Change Order

PROJECT: *(Name and address)*
St. Bernard Parish Government
New Public Library
3121 E. Judge Perez Dr.
Meraux, Louisiana 70075
Project No. 11884

CHANGE ORDER INFORMATION:
Change Order Number: 002

Item 1	Provide labor, materials and equipment for modifications to doors and hardware and interior finishes (RFC No. 005), in accordance with PCO 010R3, dated August 12, 2024.	Deduct	(\$16,638.83)
Item 2	Provide labor, materials and equipment to add transom to hollow metal Door Frame 138, in accordance with PCO 012 (RFI 23), dated March 14, 2024.	Add	\$ 1,589.00
Item 3	Provide labor, materials and equipment for roof penetration steel framing on the low roof, in accordance with PCO 016, dated April 26, 2024.	Add	\$ 1,885.00
	Add two (2) additional days to accomplish Item 3.		
Item 4	Provide labor, materials and equipment for the installation with modifications to the storm drain system (PR 006) in accordance with PCO 017R1, dated May 14, 2024.	Add	\$41,797.00
TOTAL CHANGE ORDER NO. 002		ADD	\$28,632.17

1 FLOOR PLAN - ISF-C REVISION
 1/4" = 1'-0"

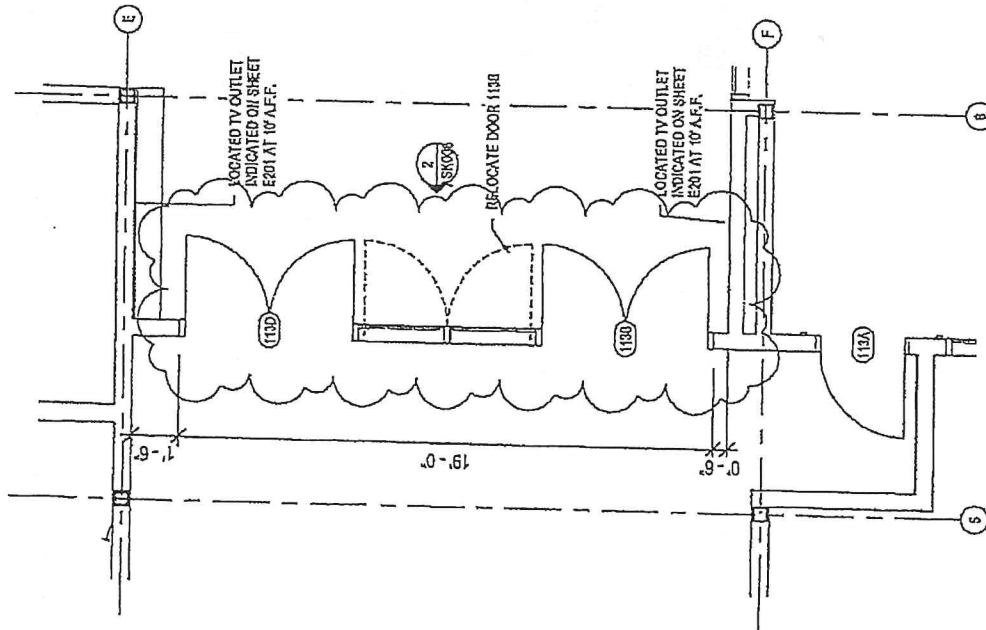
Description of Work: Remove 25LF of 6" 20ga wall, add 25lf OF Framed Furr Down, frame and hang gypsum board where doors are being removed. Frame Entrance for Multi Purpose Room as per ASK006 Revision dated 3.05.24

- Modifications Storefront at ISF-C between multi-purpose Room 113 and Exhibits per Sheet No. ASK006, dated 2/15/24.
- Storefront modifications at ISF-F, between Quiet Reading 132 and Exhibit 115, per Sheet No. ASK007, dated 2/15/24.
- Modifications to Children's Program 126, per Sheet Nos. ASK008, ASK009 and ASK010, dated 2/15/24.

PROJ. NO: MBA - 11894
 ABM - 201813
 DATE: 12/19/23
 DRAWN BY: TH
 CHECKED BY: SC
 REFERENCE SHEET: A211
 SHEET NO: ASK004

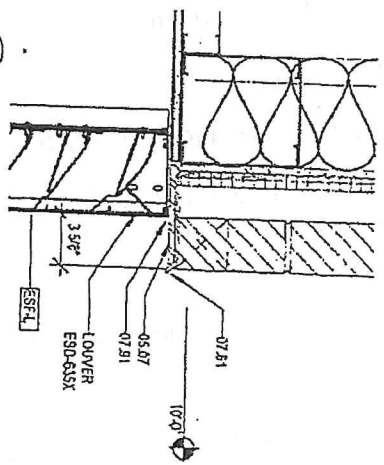
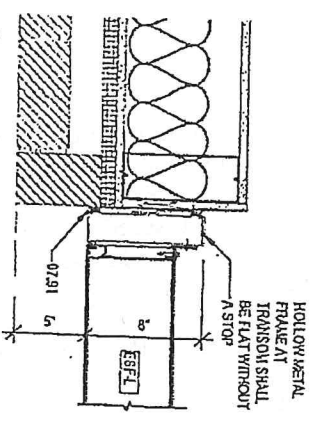
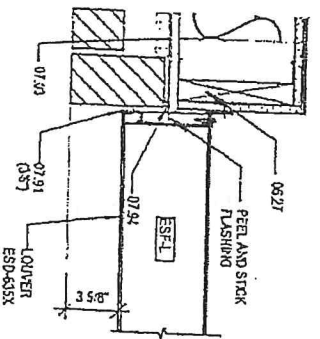
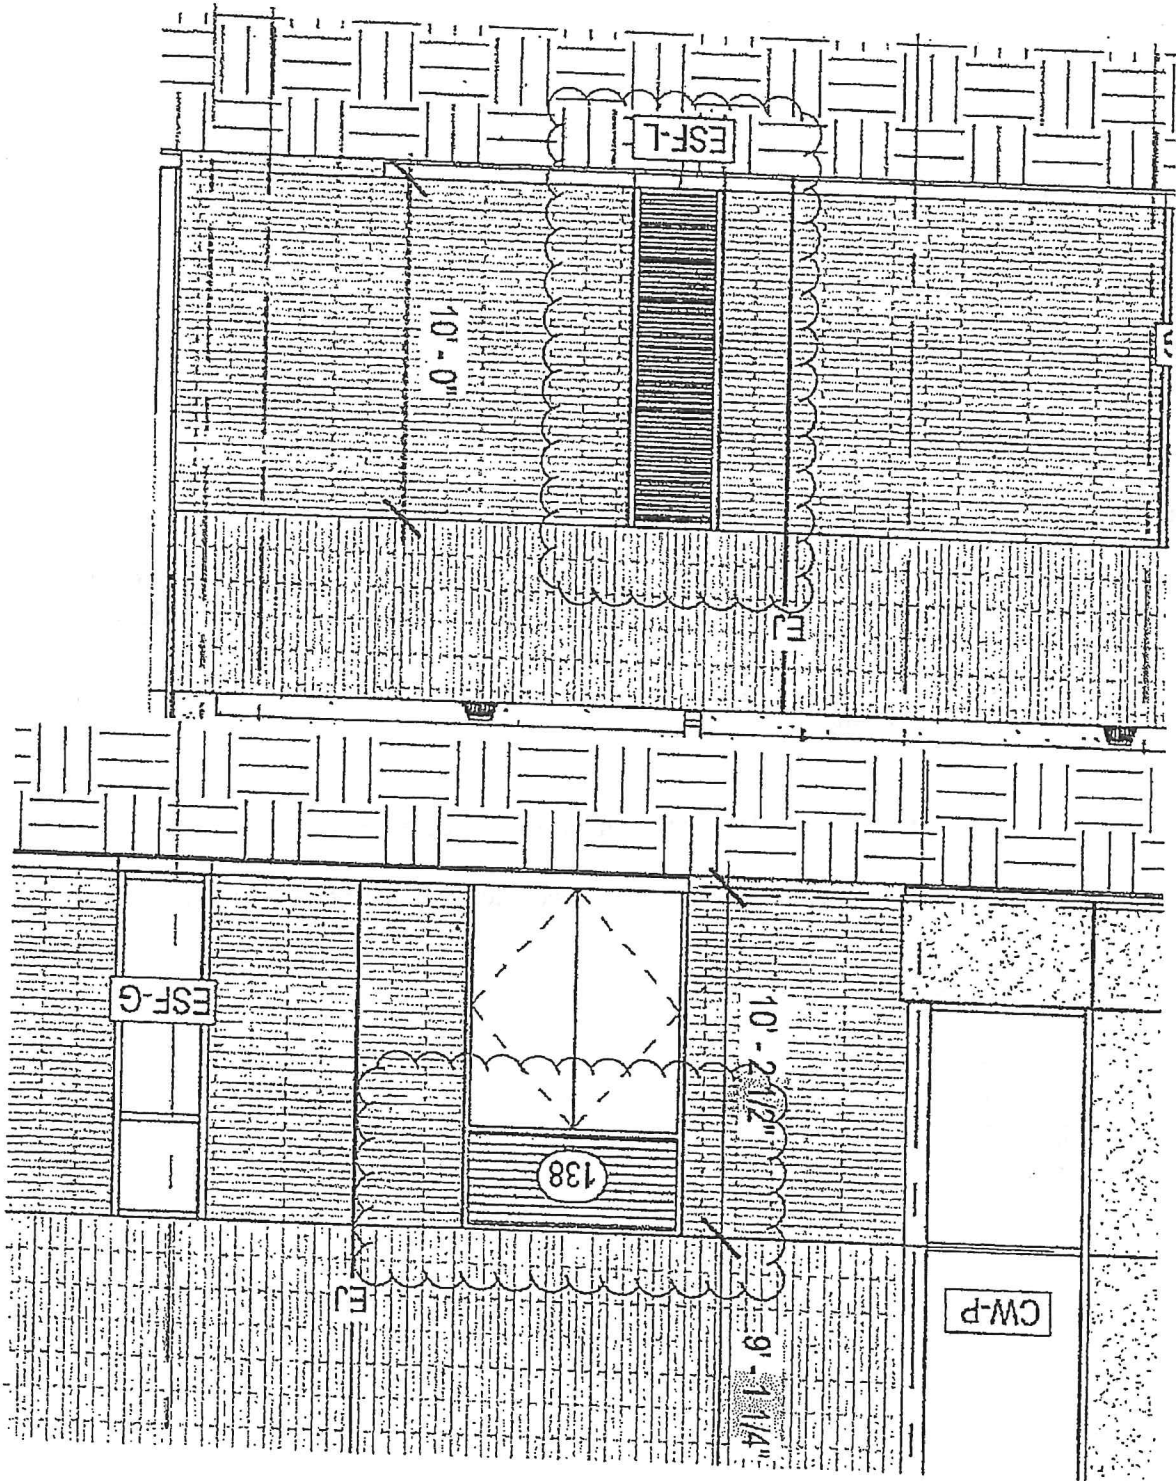
Please provide head and jamb details for the vertical louver in room 127 and the louver connected with the hollow metal door in room 138.

MBA Response: Please see attached ASK-004

LOW ROOF

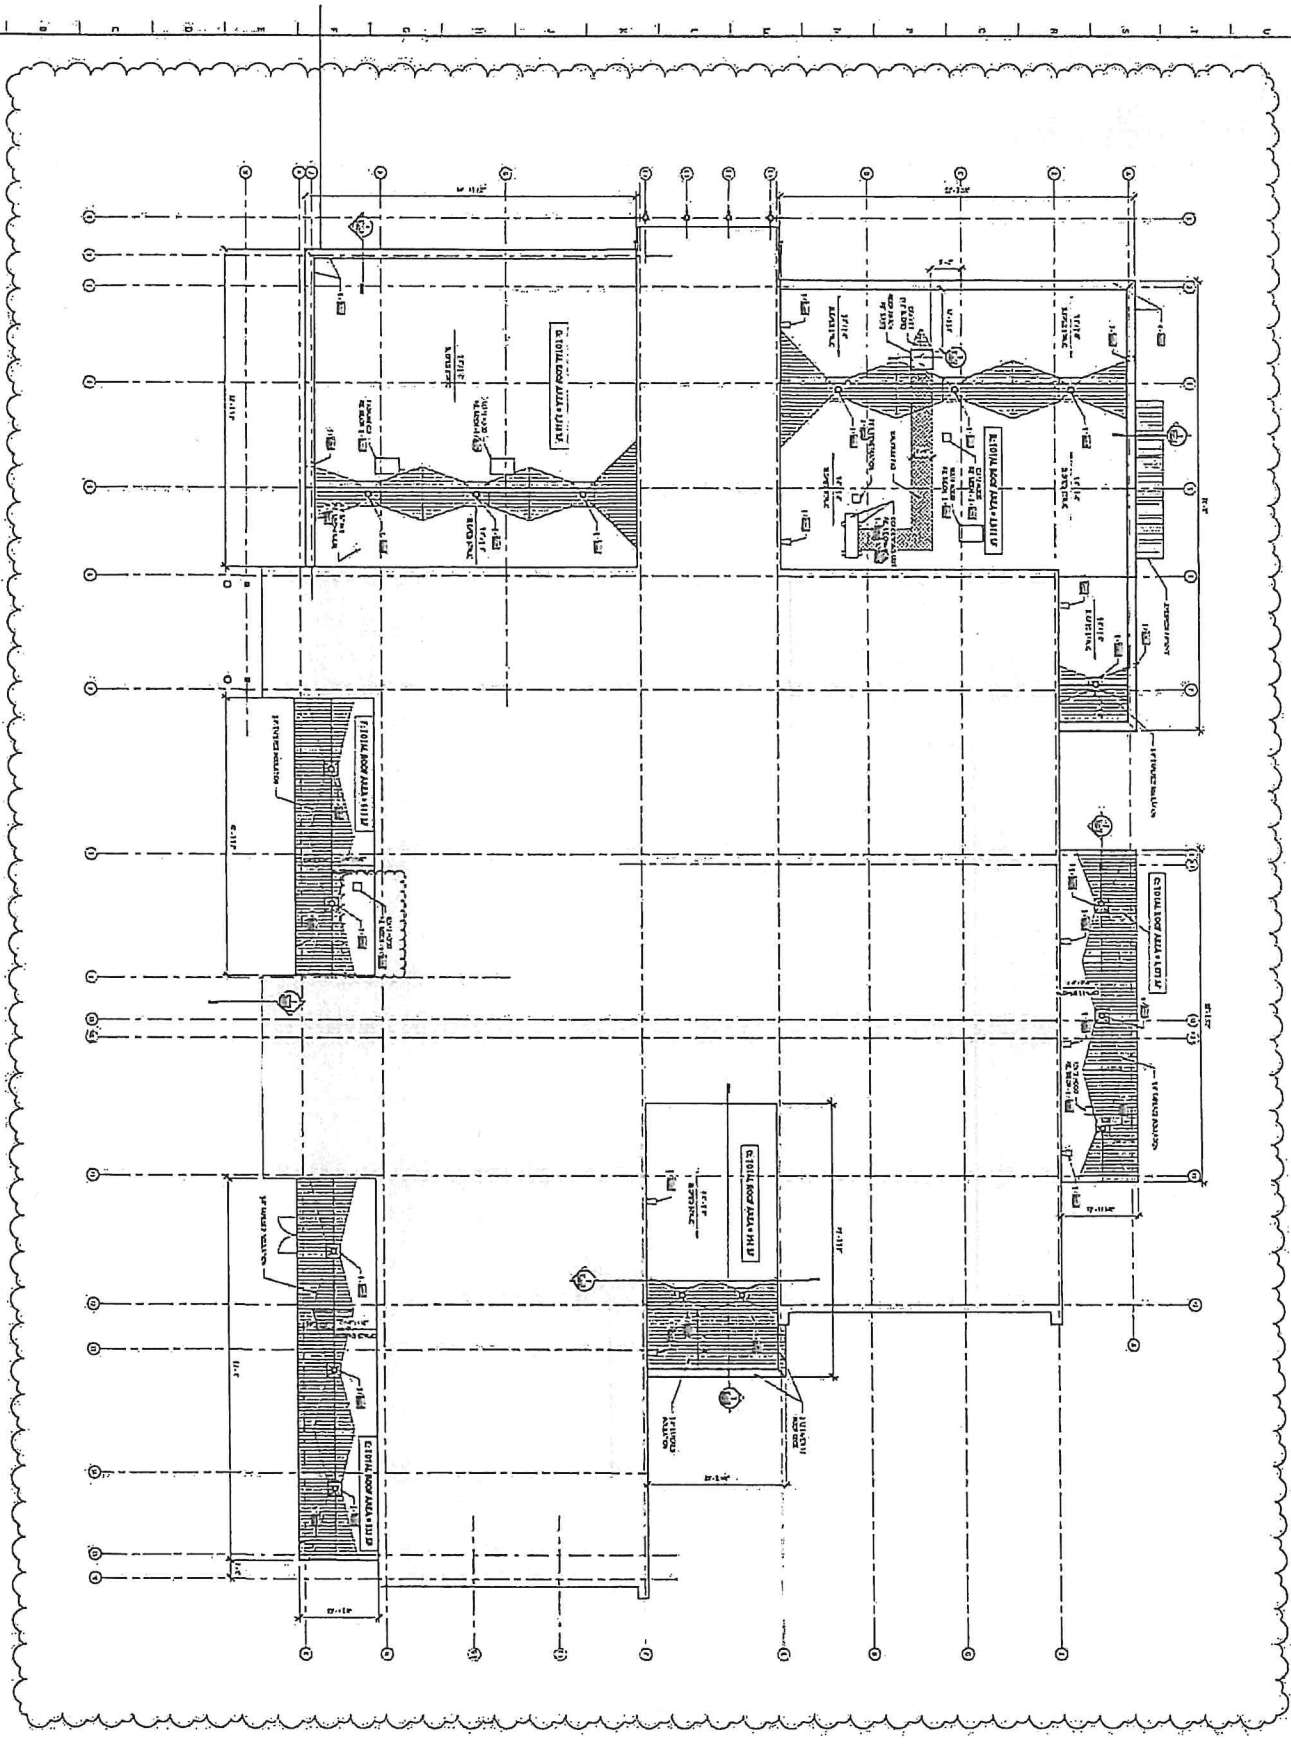
This proposed change order is for the installation of roof penetration steel framing on the low roof due to a misplaced opening on M103.

The steel erector will be demobilizing tomorrow. We need an answer regarding the direction you want to go with the roof penetration framing. Please advise quickly.

UTILITY PLAN

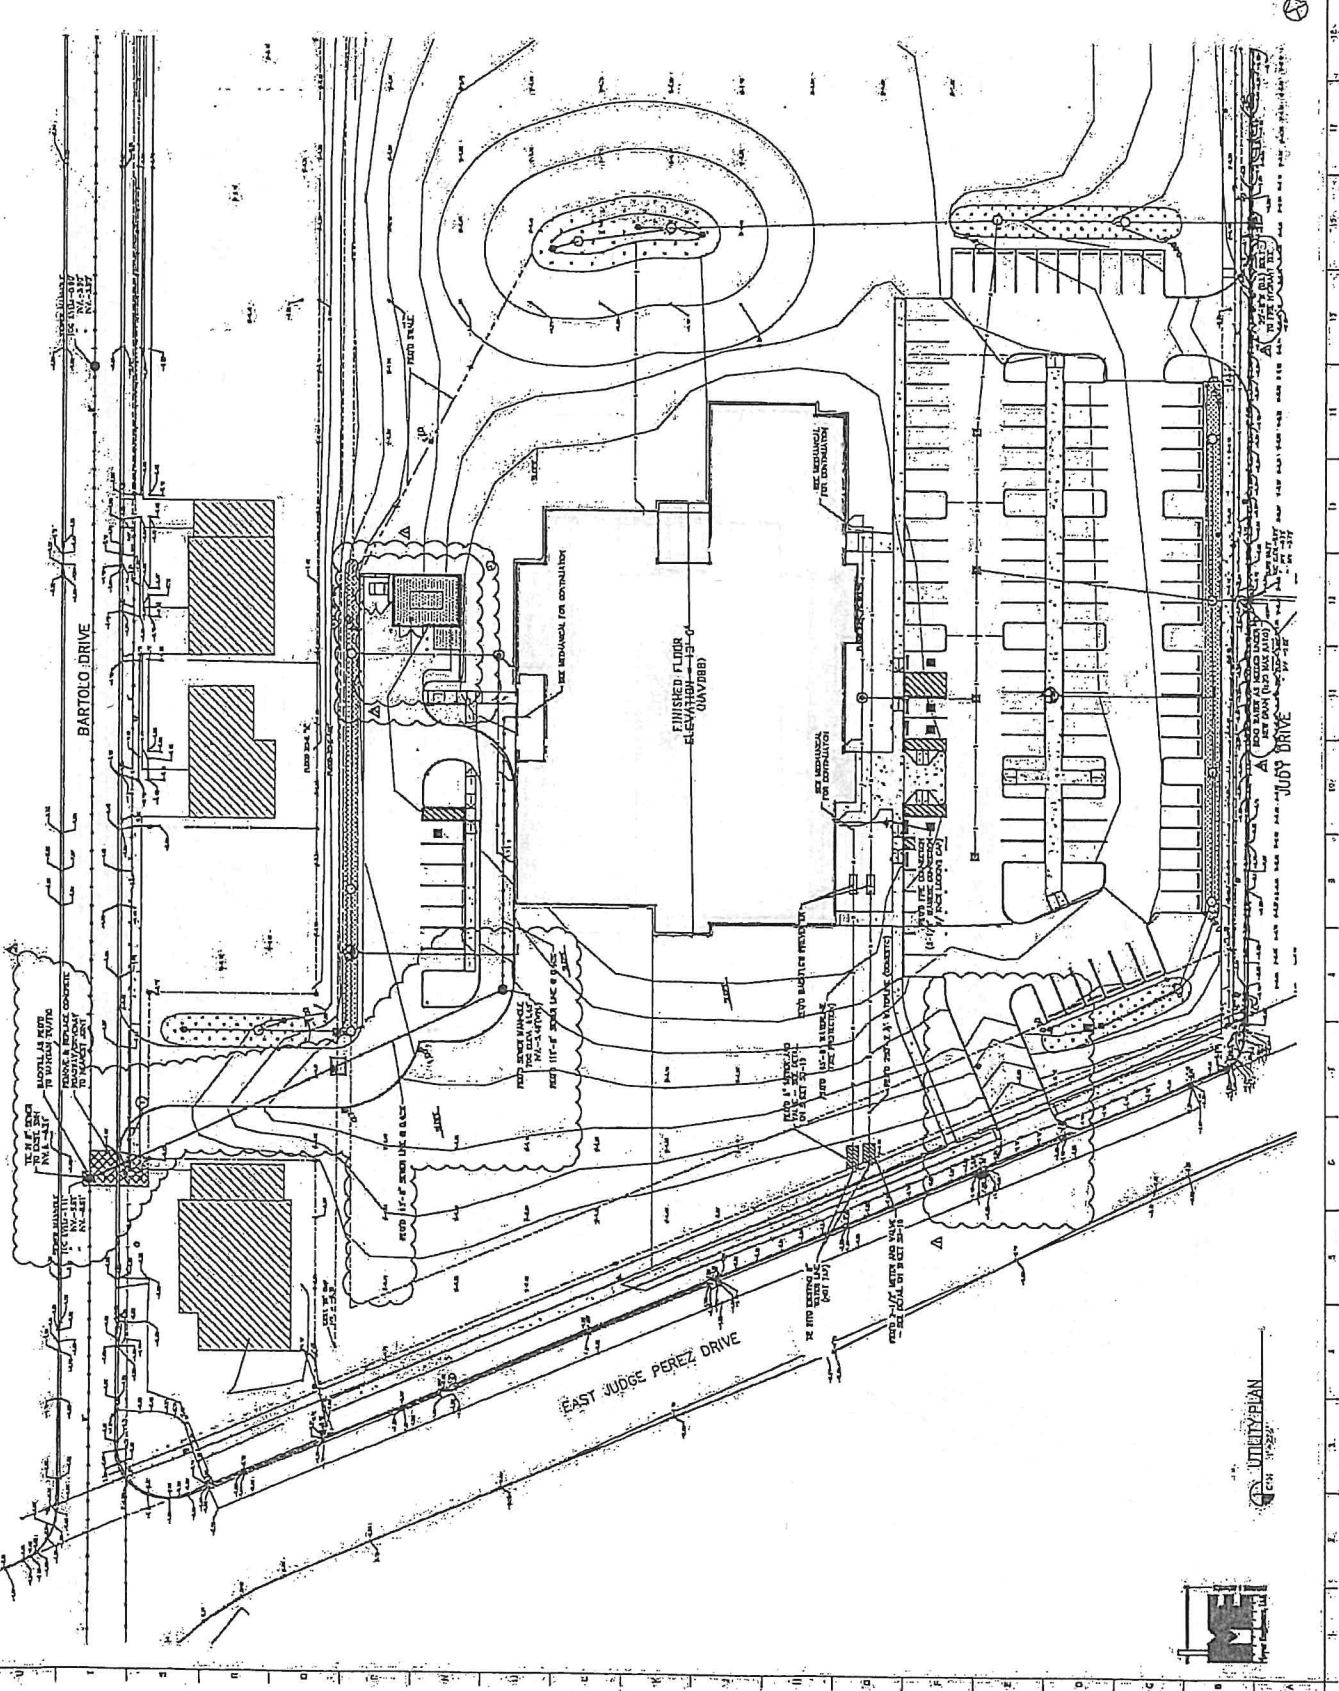
Revisions to site drainage as indicated on attached Sheet Nos. C100 and C101, dated 5/7/24, with accompanying Take-Off, Line Diagram and marked-up Shop Drawings with new elevation. Also included are SBP Standard Details Sheet Nos. SD-5 and SD-6, as per accompanying description of work as follows:

We would like the contractor to confirm the elevation of the waterlines at each of the drain line crossings prior to construction to confirm the elevations are not conflicting. There is potential for the waterline conflict on Judy near the already proposed catch basin to allow for adjustment without having to widen the catch basin or replace the waterline at this location as we show in the attached.

- b. Reallocate pipe in this area elsewhere on the project.
2. Flip the location for Overflow CB #2 and the cleanout as shown on the sketch.
3. Construct Overflow CB #7 at a new location as shown. Adjust height as shown on shop drawing markup.

4. Install Drop Inlet #4 (as labelled on shop drawing) to the location as labelled Drop Inlet #1.
5. Drop Inlet #2 shall remain in the same location. Adjust height of structure as marked up.

7. Drop Inlet #1 (as labelled on shop drawing) to location as labelled Drop Inlet #4.
 - a. Install reallocated 18" RCP from Drop Inlet #4 to a new field constructed overflow box where Overflow CB #7 (as labelled on shop drawing)
8. Connect original proposed 15" PVC into original proposed CB on Judy.
 - a. As stated above, confirm waterline elevation. There may not be as great of a conflict thus not needing an adjustment to the originally proposed CB.

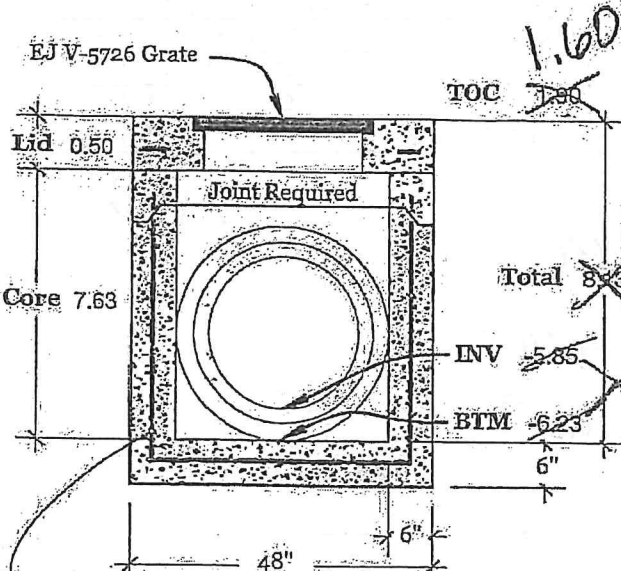
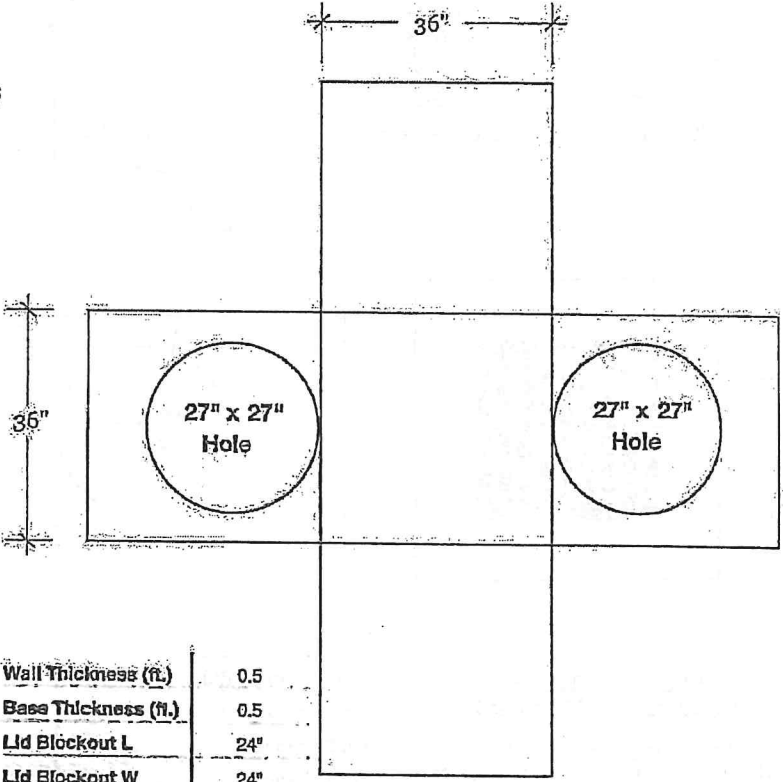
SHARPEN 1.3'

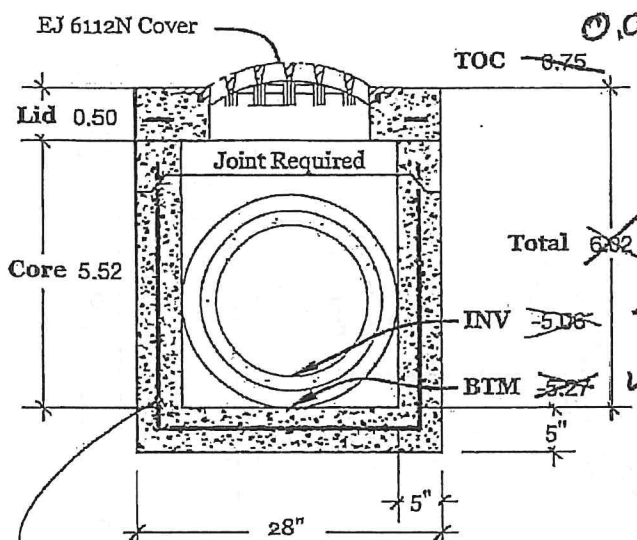
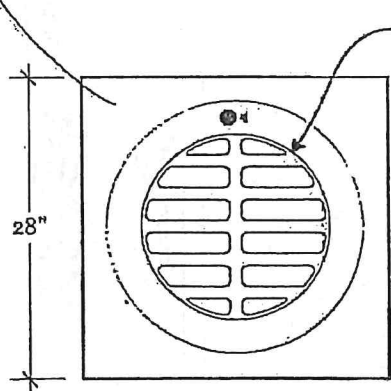
Shorten 1.38'

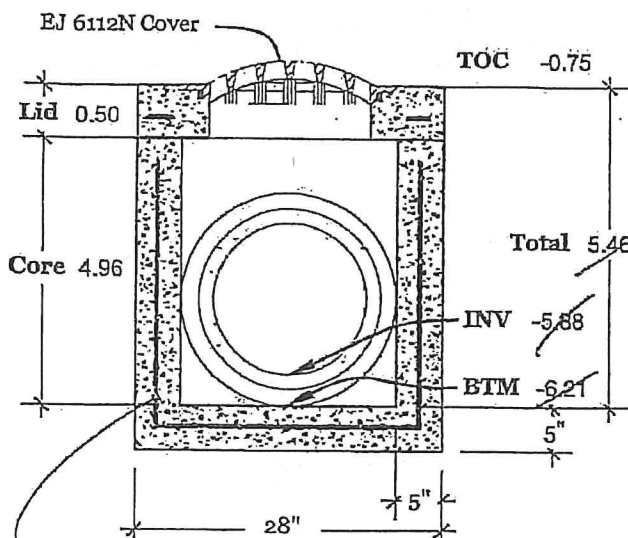
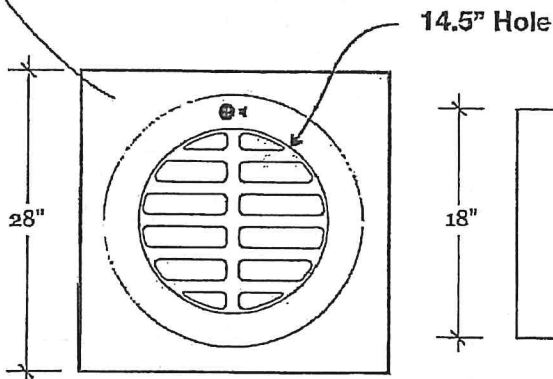
REMOVE 8" PVC
